CITY OF DOVER

PLANNING TECHNICAL REVIEW COMMITTEE –AGENDA

1. Site Plan Amendment for Jones & Beach Engineering (Owners: The Dover Condominium & Essential Properties, LLC), Assessor's Map 38 & 37, Lots 6-A & 24, zoned C, located at 851-888 & 829-833 Central Avenue. (Proposal is to convert former department store to Traene fitness facility consisting of 10 pickleball courts and fitness areas with a 24' wide driveway connection between the two parcels.) (WAIV-2025-0012) [This item was previously heard by the Planning Technical Review Committee on November 6, 2025.]

RE: Response Letter
829-833 & 851-881 Central Avenue, Dover, NH
Tax Map 37, Lot 24
Tax Map 38, Lot 6A
JBE Project No. 20523

H1

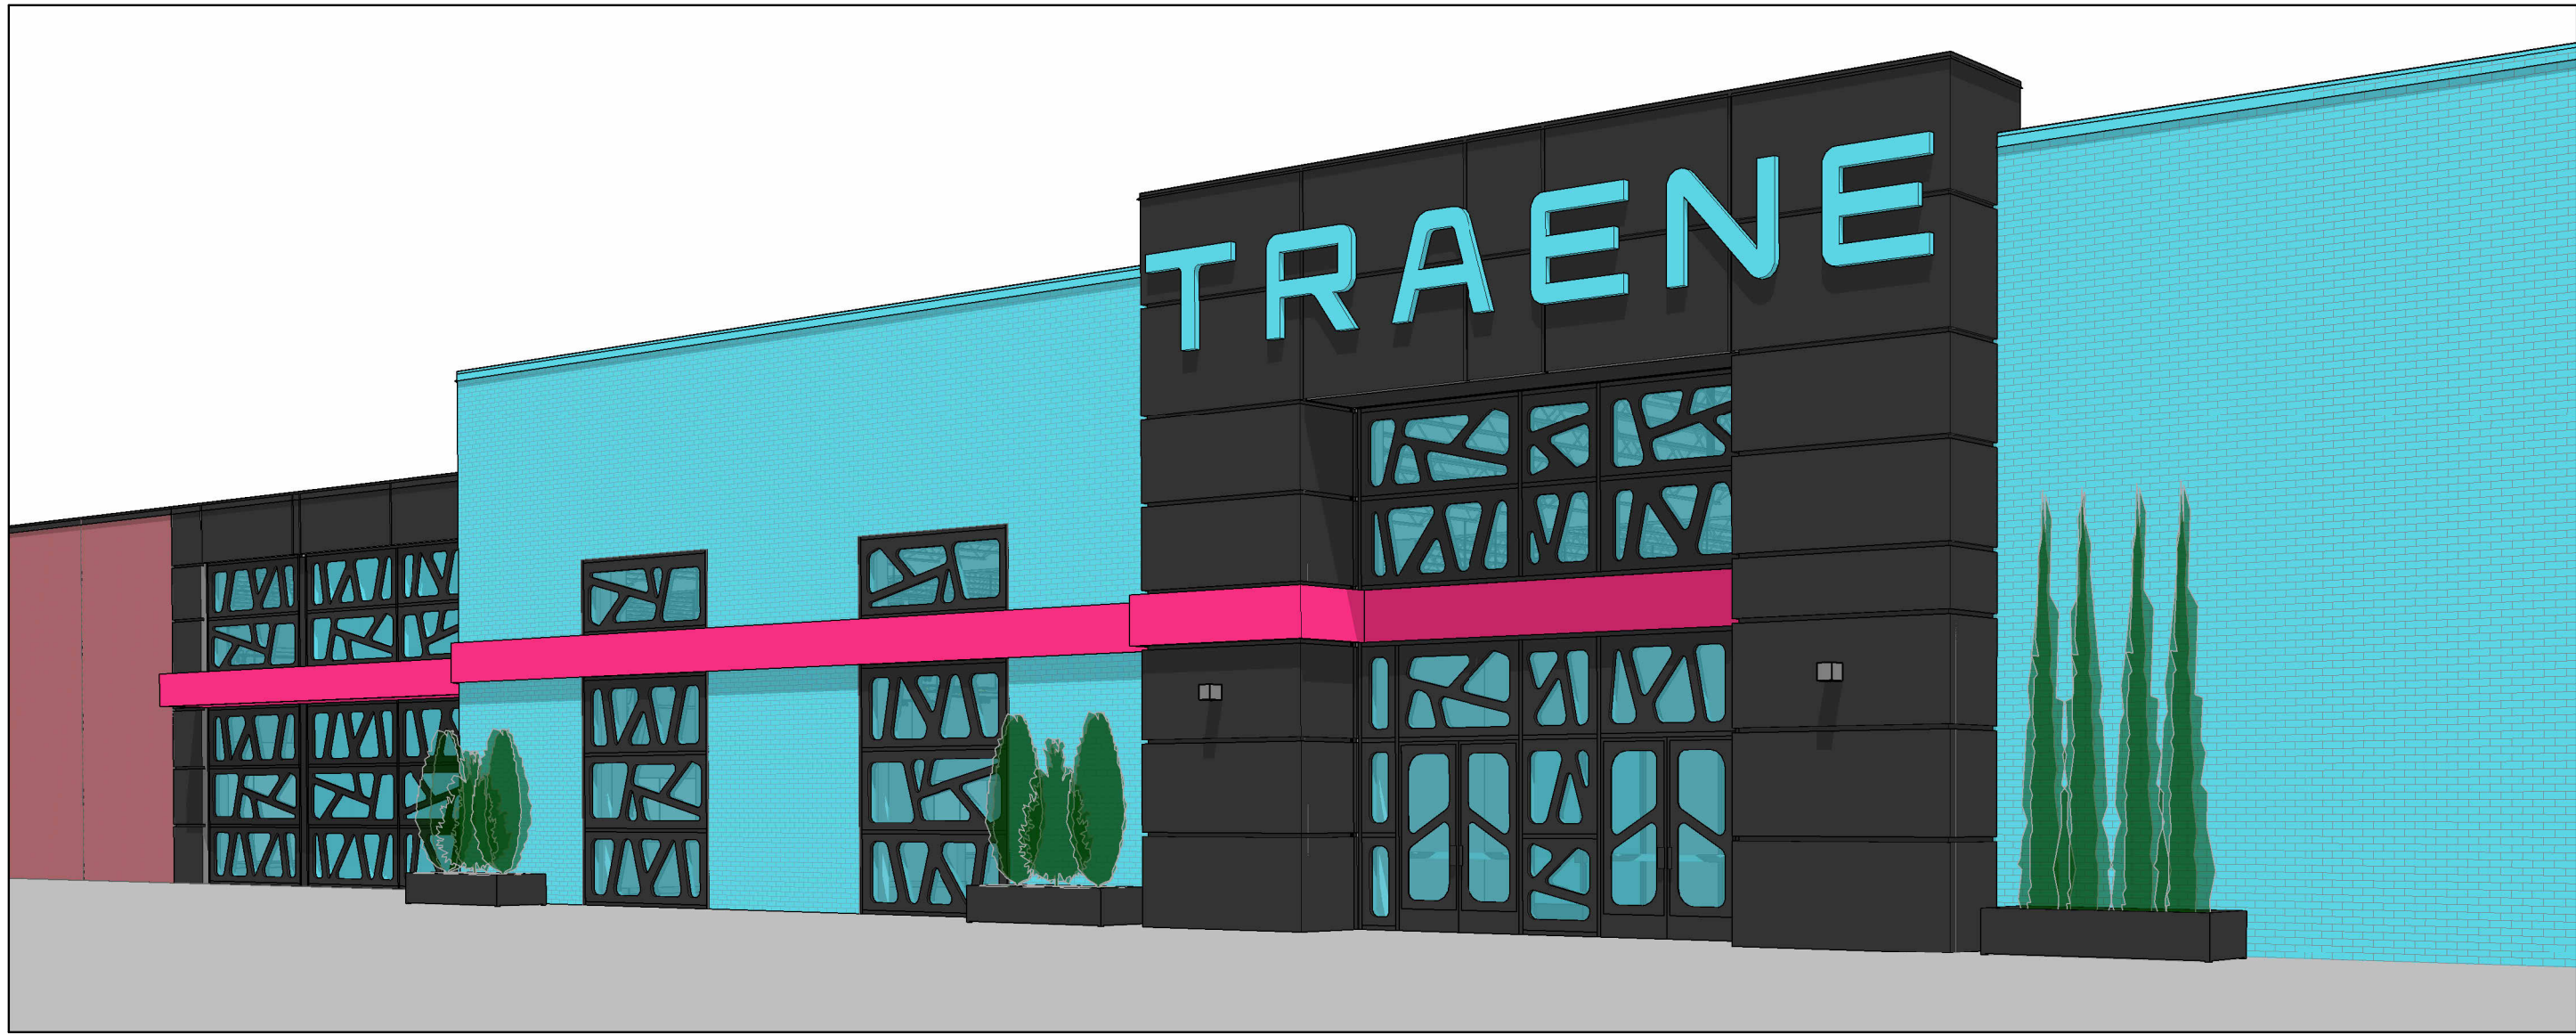
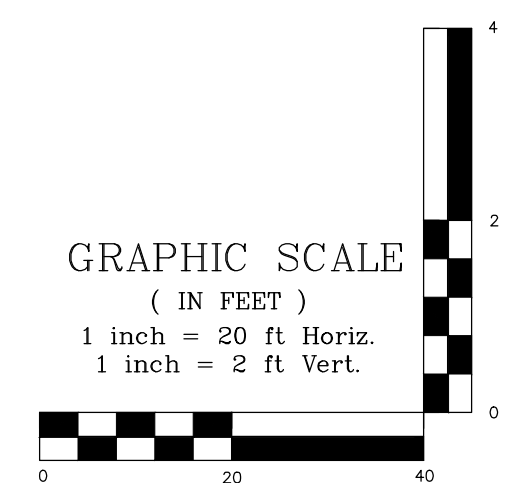
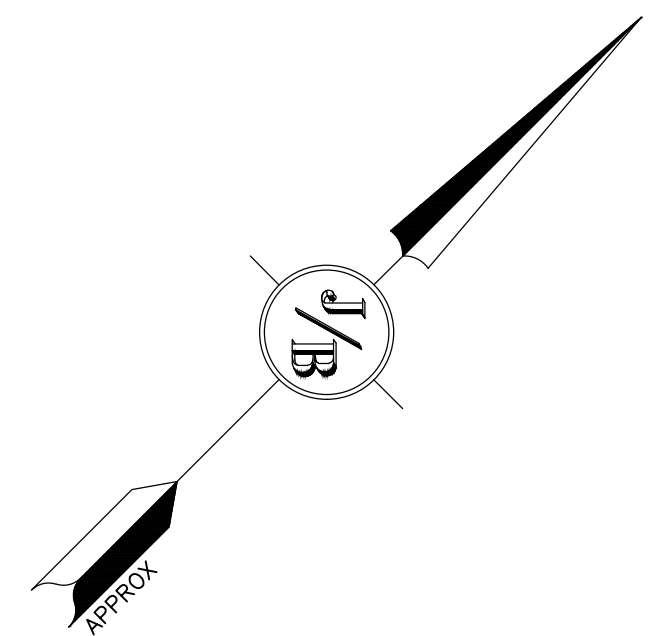
- *Accessway:*
 - *Has sight distance been measured?*
Response: Sight distance measurements have been added to the plans on Sheet H1 at the end of the set. See below response to police comments for a more detailed explanation.

Response: See sight distance profile on Sheet H1 at the end of the plan set. We performed a sight distance analysis in the field and found that there is 169'-2" available stopping sight distance to the north of the proposed driveway connection, exceeding the required 110.8' stopping sight distance per AASHTO assuming a 20-mph design speed at a 1% slope. Additionally, 259' stopping sight distance is provided from the existing right lane slip ramp to the proposed driveway connector, and a greater sight line than that is provided to the actual intersection. This additionally exceeds the 114.4' stopping sight distance required per AASHTO at a 2.2% slope assuming a 20-mph design speed. As noted in the inset on Sheet C2, vegetation shall be removed as necessary for improved visibility from the proposed connector driveway. See enclosed sight distance photo log. A trip generation memo is included with this resubmission as well.
